SERVICE BULLETIN

N° **139-729**

ATA 28 – FUEL PORT MODIFICATION

AW139 helicopters from S/N 41801 to S/N 41804.

Figure 16

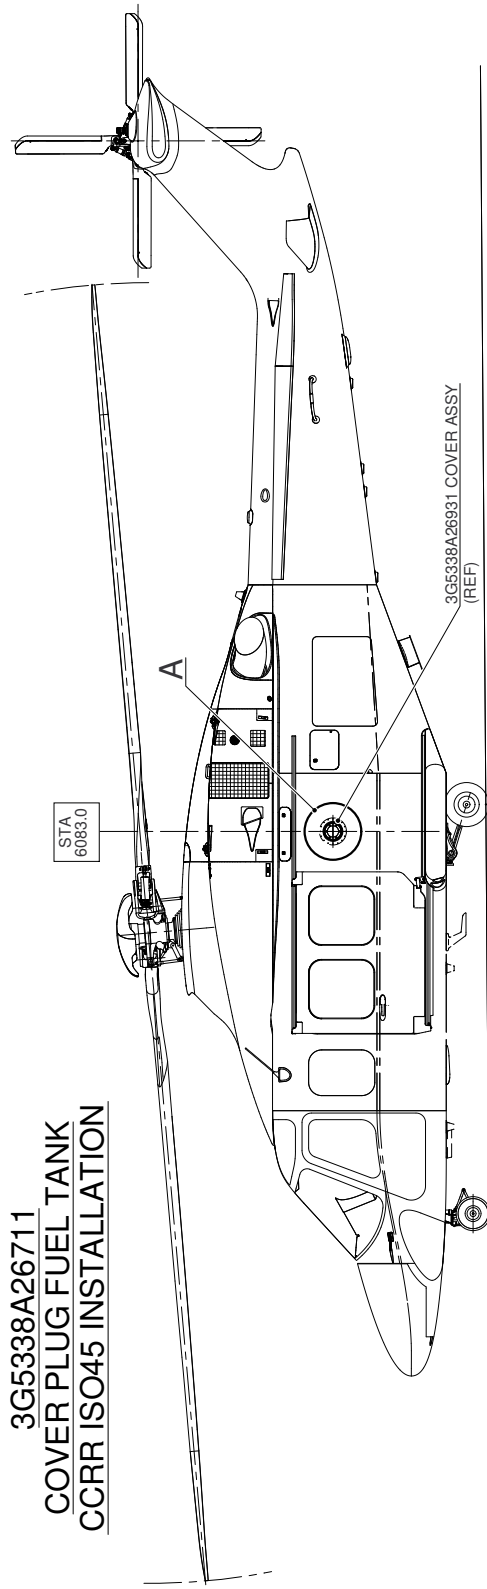
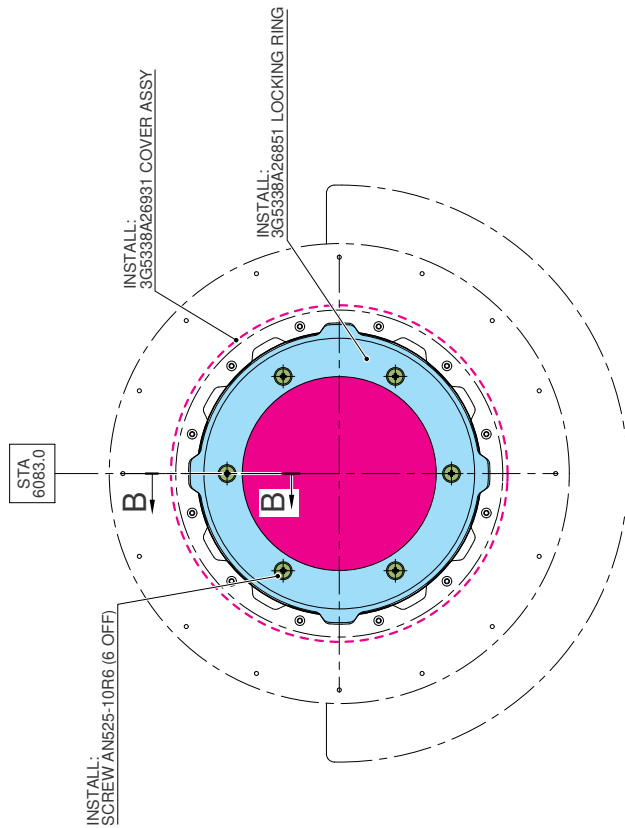
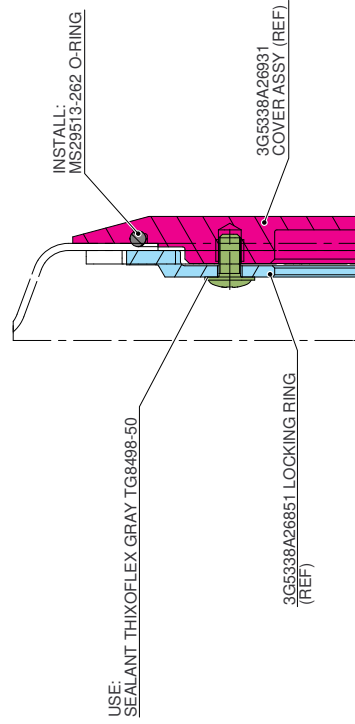
- 4.1 With reference to Figure 16, install the cover assy P/N 3G5338A26931, the locking ring P/N 3G5338A26851 and the O-ring P/N MS29513-262 by means of n°6 screws P/N AN525-10R6.
5. In accordance with AMP DM 39-A-06-41-00-00A-010A-A, re-install all external panels, internal panels and internal liners previously removed.
6. In accordance with weight and balance changes, update the Chart A (see Rotorcraft Flight Manual, Part II, section 6).
7. Return the helicopter to flight configuration and record for compliance with this Service Bulletin on the helicopter logbook.
8. Gain access to My Communications section on Leonardo WebPortal and compile the "Service Bulletin Application Communication".
